Visy Dry Recyclables Facility

112 – 120 Euston Road, Alexandria

Additional Information and Response to Submissions

SSD-10364

Figure 2.1. Encroachment into tree protection zones from EIS Aboricultural Assessment

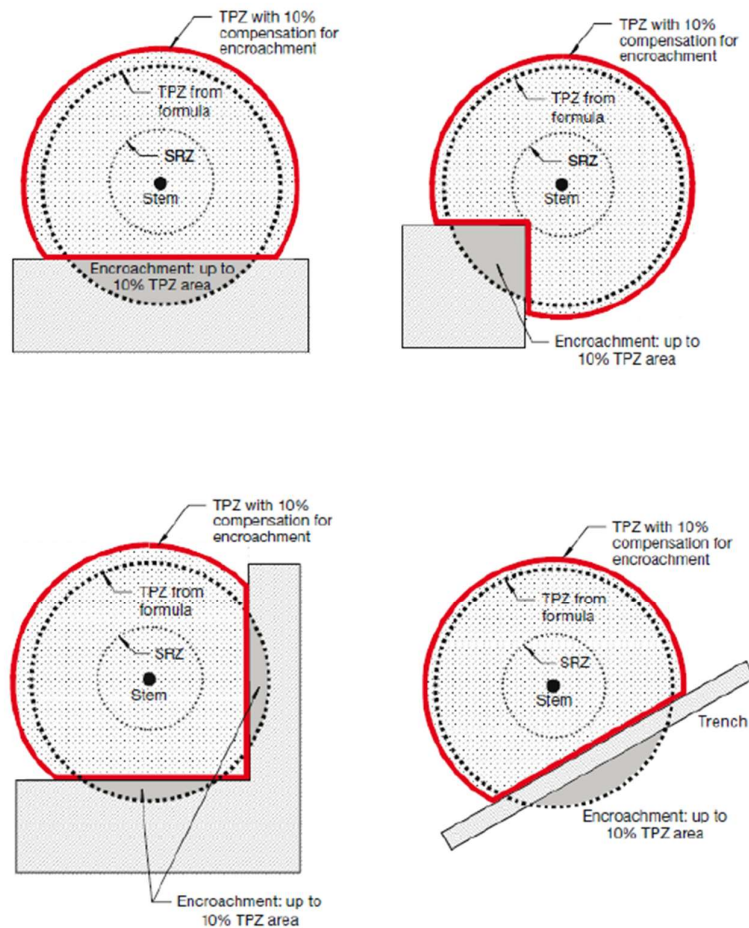
The plans in **Appendix A** have corrected the illustrated Structural Root Zone (SRZ) and Tree Protection Zone (TPZ) for the three trees on the Euston Road frontage which had been inaccurately illustrated using the measurements as a diameter rather than a radius.

The 10% encroachment into TPZ is illustrated in the Arboricultural assessment with the figure shown in **Figure 2.1**.

The landscape plan retains the *Eucalyptus microcorys* (Tallowwood) on Euston Road. The stage 2 new substation kiosk will be located so that it will achieve not more than 'low impact' on the Tallowwood.

The plans in **Appendix A** illustrate a relocated position of the fire system hydrant and sprinkler booster which intrudes less on the TPZ of the *Corymbia citriodora* (Lemon scented gum) on Euston Road than the original plans accompanying the EIS. The impact on the TPZ will be 'low impact'.
